UNITED STATES PATENT AND TRADEMARK OFFICE

APPLICATION NO.	FILING DATE	FIRST NAMED INVENTOR	ATTORNEY DOCKET NO.	CONFIRMATION NO.
09/892,883	06/28/2001	Hong Man Moon	8733.426.00	3032

Office Action Summary

DETAILED ACTION

FIG. 5a

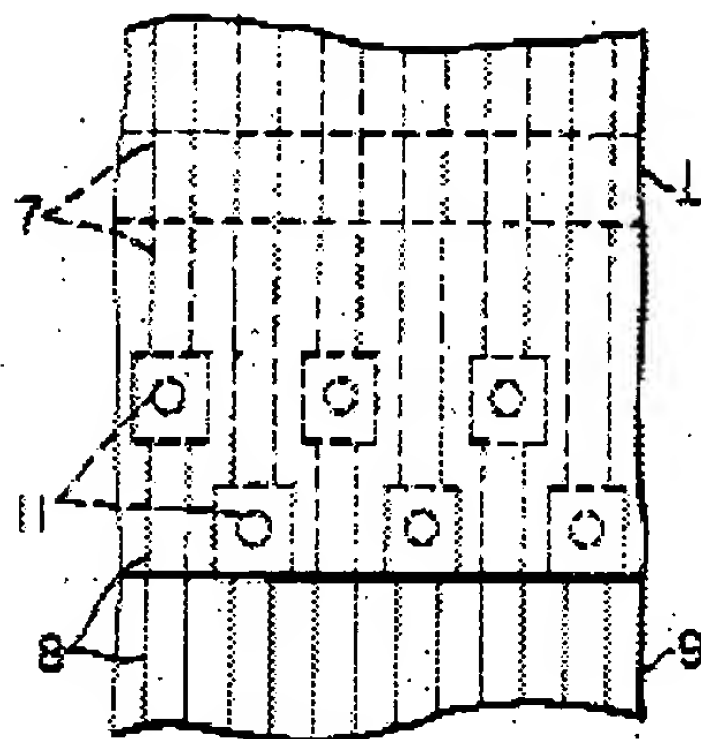
APA does not explicitly disclose a display wherein the predetermined distance is greater than or equal to 1mm (claim 6); equal to or greater than 1mm and less than or equal to 1.5mm (claim 8); or greater than 1.5mm (claim 9) to prevent deterioration of liquid crystal generated in said outer area from being diffused into the thin film transistor array, although it may be very likely that numerous conventional in-plane switching mode liquid crystal display devices comprising the above features were marketed in the United States more than one year prior to the claimed invention.

Tanaka teaches in Figures 1-5 the use of terminal and conductor (Applicant's line) spacing in the ranges of 1.5mm or more (col. 1, lines 5-18) and 1.0mm or more (col. 1, lines 22-34) in order to connect them to an external circuit.

Tanaka is evidence that ordinary workers in the art of liquid crystals would find the reason, suggestion, or motivation to use a predetermined distance that is greater than or equal to 1mm; equal to or greater than 1mm and less than or equal to 1.5mm; or greater than 1.5mm in order to connect them to an external circuit.

Therefore, it would have been obvious to one having ordinary skill in the art of liquid crystals at the time the invention was made to modify the LCD of APA with the predetermined distance of Tanaka that is greater than or equal to 1mm; equal to or greater than 1mm and less than or equal to 1.5mm; or greater than 1.5mm in order to connect them to an external circuit.
